DOCUMENTATION TRANSMITTAL

Documentation Description: NONCONFORMANCE REPORT: C-00028

NONCONFORMANCE REPORT

1 ITEM LOCATION  
Reactor Building, Unit #2, Elev 613'

| SHEET NO. FSK-M-LCEB-W-4-H-2       |          |                  |             |                  |

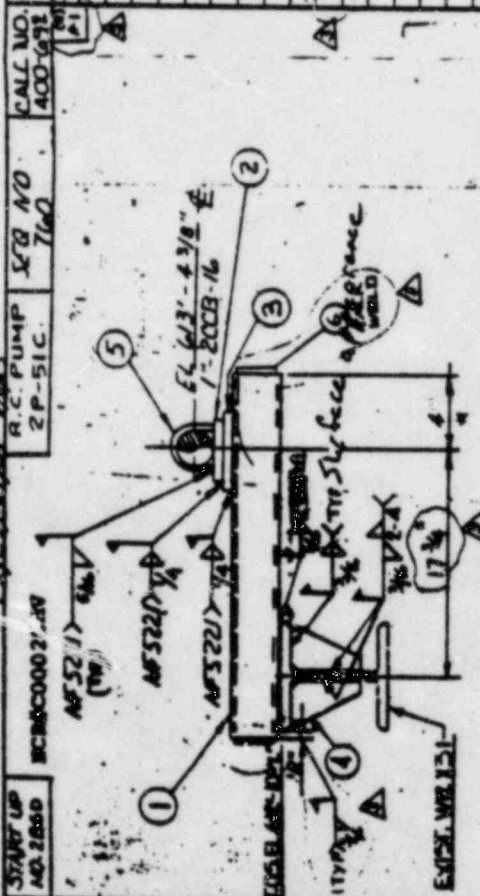
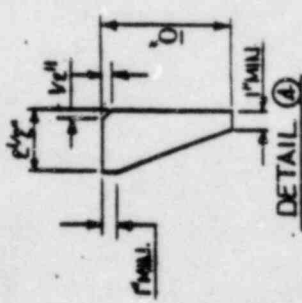
12 REQUIREMENT  
1) PQC: 7220/P2.30 Rev.3 para. 3.1.14 (G-27, VT-ASME, NF-5360) states "welds shall be free of coarse ripples, irregular surface, high crown and deep ridges or valleys between beads and shall be essentially uniform in size throughout their length."

13 NONCONFORMANCE  
1) Contrary to the above the welds connecting item #1 to the existing steel has an irregular surface appearance on both the north and south welds.

JUSTIFICATION REWORK THE NORTH & SOUTH WELDS OF ITEM #1  
TO THE EXISTING STEEL TO ELIMINATE IRREGULAR SURFACES.  
THE IRREGULAR SURFACES POSSESS DEEP CRACKS - FUSION  
CANNOT BE VERIFIED. ∴ REWORK THE WELDS.

31A ADDITIONAL INFORMATION USE AS IS - WELD SURFACE IRREGULARITIES ARE NOT EXCESSIVE. MINIMUM WELD SIZE CAN BE VERIFIED AND NO OTHER DEFECTS ARE VISUALLY PRESENT. R.G. *Blk* Tag 1/20/84 (SEE PAGE 4 FOR CONT.)

ITEM #1 PROJECT ENGINEERING CONCURS WITH THE FIELD  
ENGINEERING RECOMMENDED DISPOSITION TO 'USE AS IS'

WELD SURFACE IRREGULARITIES DO NOT INFRINGE UPON THE MINIMUM  
WELD THROAT THICKNESS REQUIREMENT & REQUIRED NON DESTRUCTIVE  
EXAMINATION OF WELD. NO DRAWING REVISION REQUIRED. NO  
IMPACT ON QUAL TEST. CALCULATION # 400-69200 HAS BEEN  
ANNOTATED IN ACCORDANCE WITH EDPI 4.37.0.

| ITEM NO. | DESCRIPTION  | ACTION REQUIRED/TAKEN |
|----------|--|-----------------------|
|          | HANGER WELDS (P117)<br>AFTER BRUSHING THE RUST OFF<br>THE SURFACE APPEARANCE IS OK<br>RECOMMENDATION - USE AS IS | ACCEPTABLE            |
